OAK RIDGE NATIONAL LABORATORYOPERATED BY MARTIN MARIETTA ENERGY SYSTEMS, INC.
FOR THE U.S. DEPARTMENT OF ENERGYPOST OFFICE BOX 2008
OAK RIDGE, TENNESSEE 37831-8168

June 4, 1993

On Tuesday, May 4, I traveled to the Palo Verde Nuclear Power Plant, near Phoenix Arizona, to review their eddy-current inspection of their steam generators. This plant has three identical units, each producing about 1250 MW of power, and each having two Combustion Engineering System 80 steam generators. Unit 2 experienced a tube rupture in Steam Generator 2 on March 14, that resulted in leakage of about 250 gallons/min. from the primary to the secondary loop. The plant was safely brought to shutdown and the steam generators opened and examined. The ruptured tube was determined to be due to a long axial defect in the free span of the tube, between the 8th and 9th egg-crate support plates of tube R117 C144 in steam generator 2.

Figure 1 Rotating pancake scan of tube R105 C156 of steam generator 2, made in April of 1993.

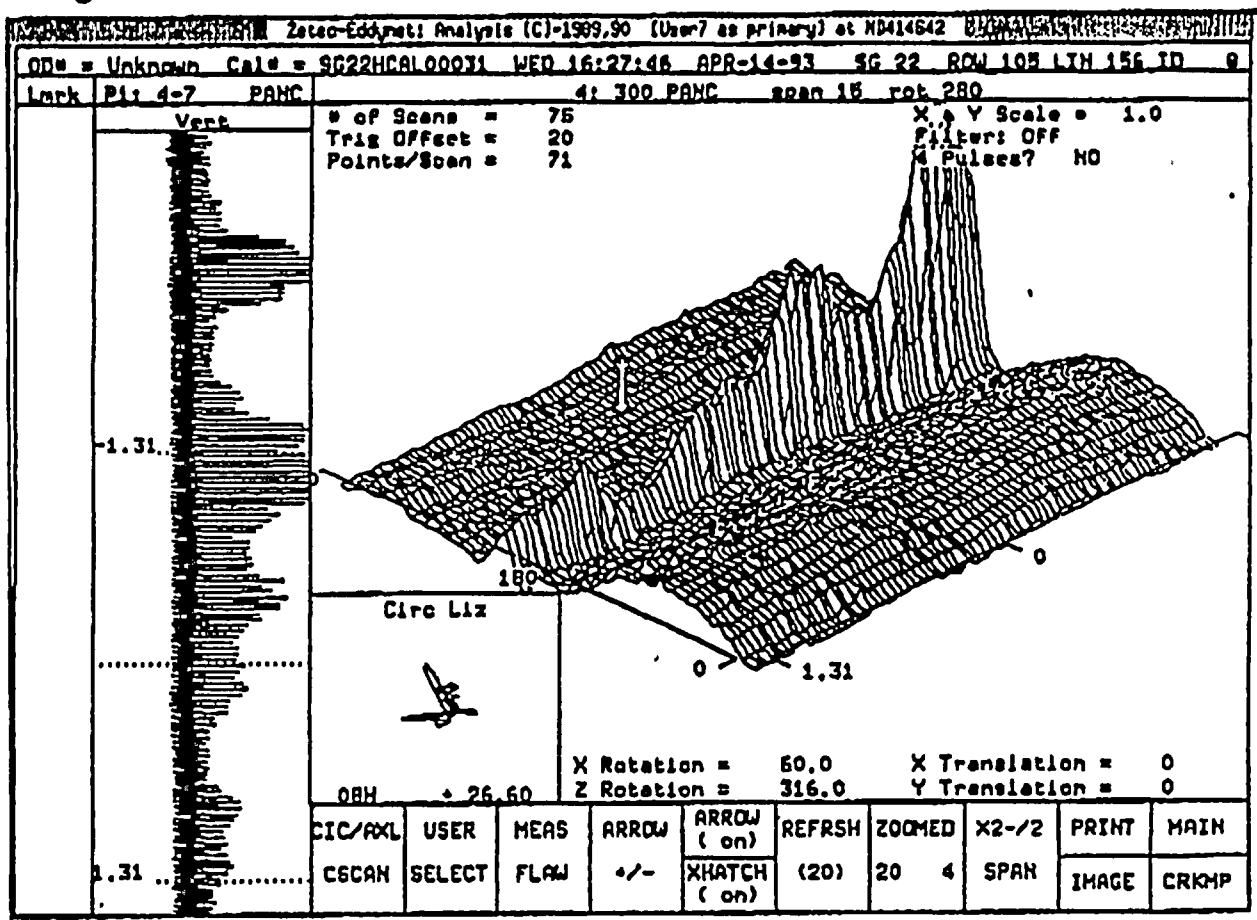
as large that was over 2 1/2 in. long and over 80% deep. This tube probably would have ruptured soon, or if there was a transient. A rotating pancake scan of this tube is shown in Figure 1.

Figure 2 Bobbin coil scan made of tube R105 C156 of steam generator 2 in November of 1991.

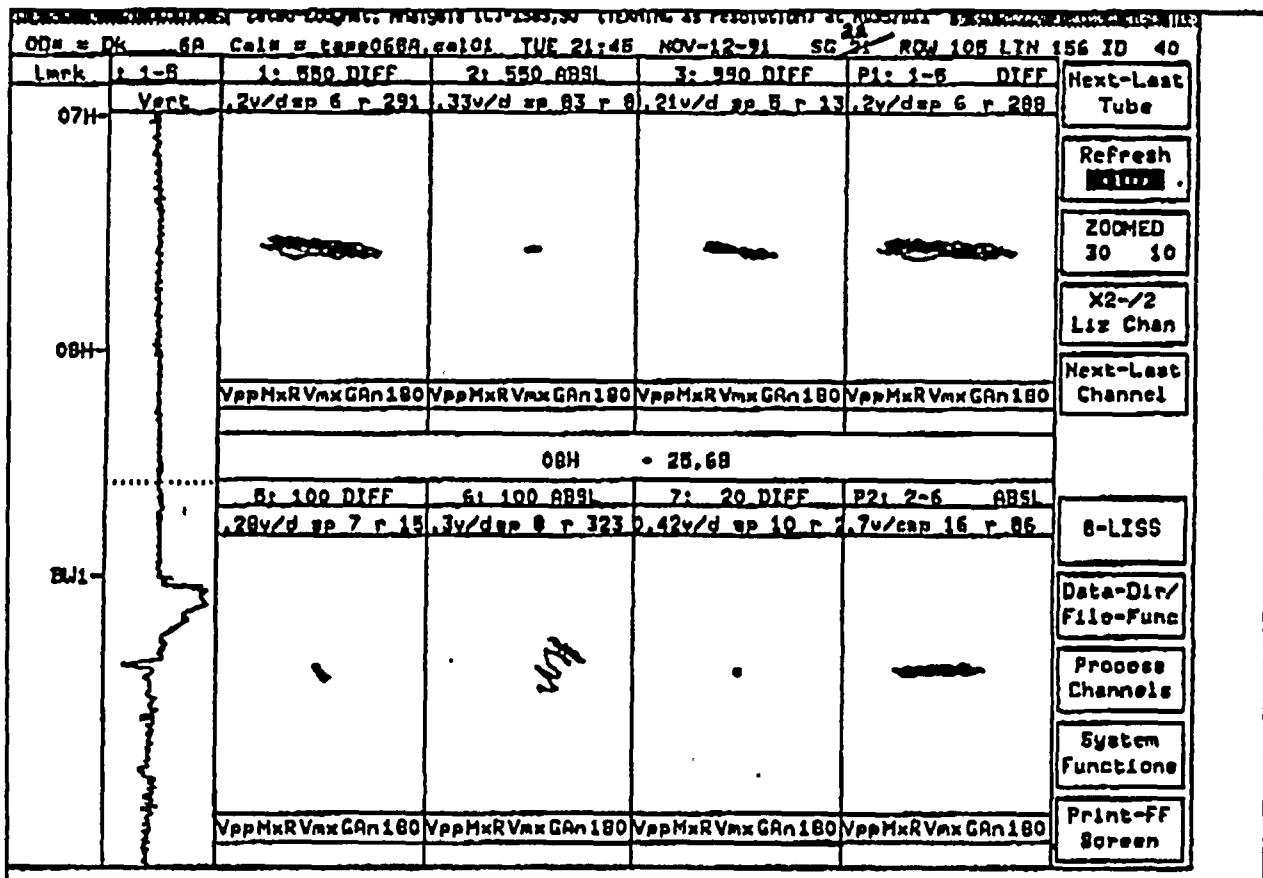
This tube had been inspected at the prior outage in November of 1991 using the bobbin probe. A bobbin coil plot of the tube at this location is shown in Figure 2. There is no indication at this location on any of the 8 lissajous plots. There is some small drift on the 100 KHz absolute channel, but this is normal for this type of tube scan. When the location of the defect is well known, a more sensitive examination of a particular region can be made, and the pilgering noise is less of a factor. This tube does not show even any "noise signals" that may be the start of a defect on the bobbin coil scan.

Figure 3 Bobbin scan of tube R105 C156 of steam generator 2 in April of 1993

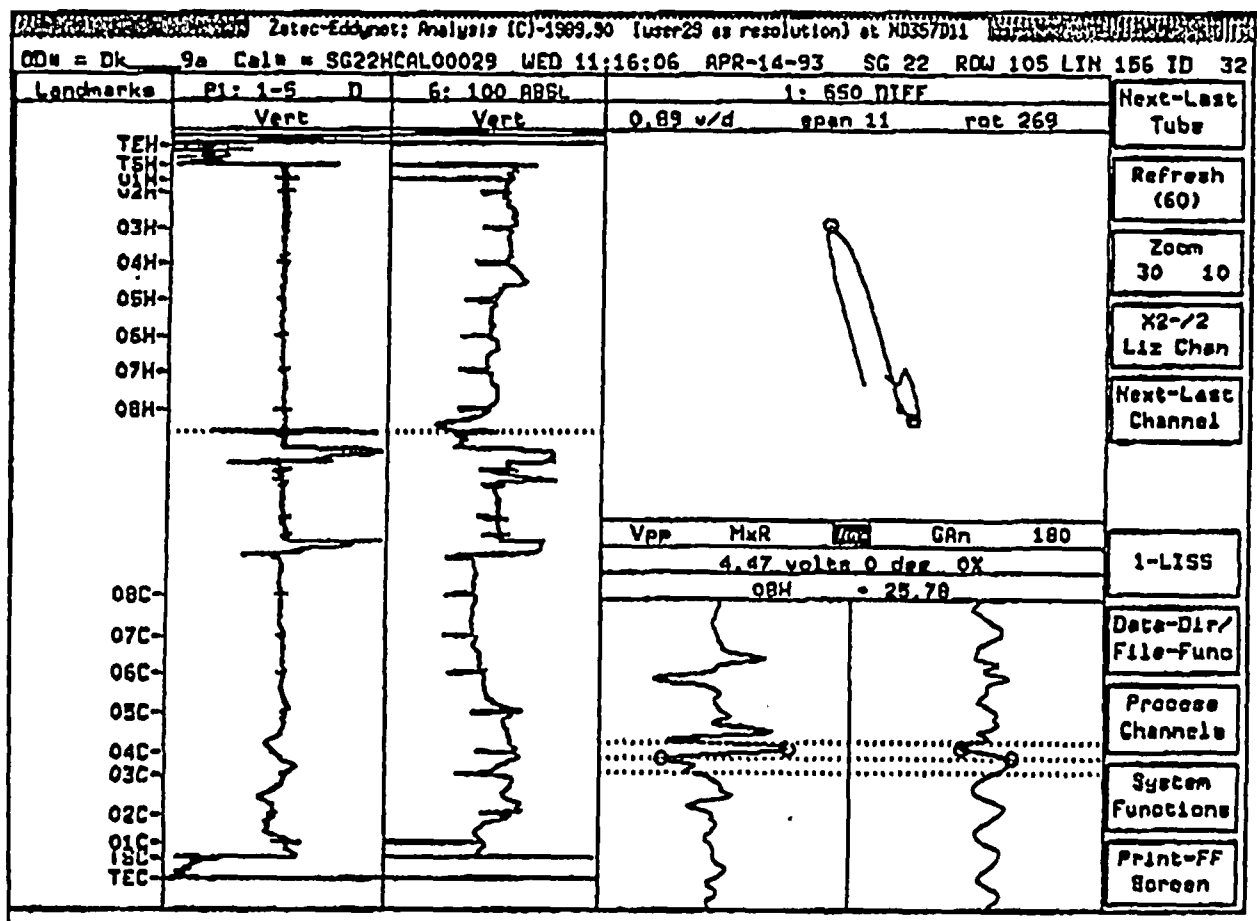
The scan in Figure 2 can be compared to the scan in Figure 3. Figure 3 is the bobbin coil scan of the same tube made in April of 1993. The defect is clearly visible in the 550 KHz differential channel, with a signal level of 4.47 volts. The expanded horizontal channel, (the right hand chart under the lissajous) shows the defect and the "sine wave" effect of pilgering, which is somewhat greater than a volt. The expanded vertical channel (the left hand chart under the lissajous) shows several vertical signals. This relatively long defect gave several "hits" on the differential channel, indicating that the defect was irregular, with stopping and starting points. The defect depth, which is measured from the angle of the lissajous figure, was reported as 80% at this point, and 84% at another. Since the pilgering noise has a direct effect on the phase angle (by varying the horizontal position of the signal) there can be considerable error in the depth measurement, particularly when the horizontal variation is greater than the vertical defect signal. However, from the amplitude of this signal, the length of the indication, the RPC scan

of the defect, and considering the measured depth on several of the bobbin "hits", the defect is probably in excess of 80% in places.

Figure 4 Bobbin probe scan of tube R117 C144 (ruptured tube) made in November of 1991

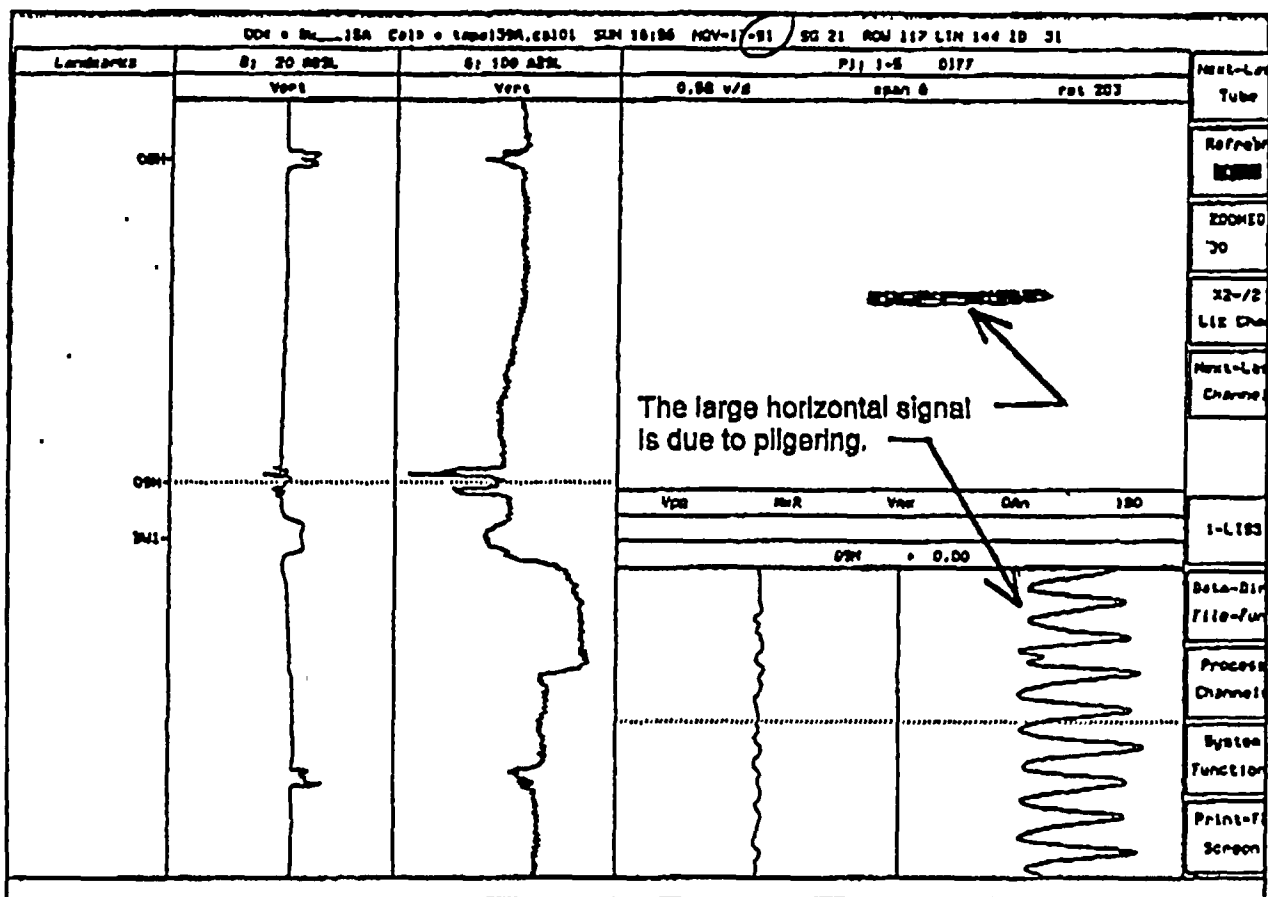
In Figure 4 we show the bobbin trace of the ruptured tube made in November of 1991. The sensitivity of this plot is much larger than the former plot, and the pilgering noise is showing up much greater on the horizontal channel. There is essentially no vertical signal in the region of the defect.

Neither of these tubes had any trace of a bobbin coil signal in the prior outage, indicating that the cracks were quite fast growing. While the pilgering noise can reduce the detection level of the bobbin probe, if the analyst knows the exact spot to examine, the reduction in sensitivity is not as large. However, there was no bobbin indication at all on these scans. Since this tube did rupture, we can conclude that with the current bobbin
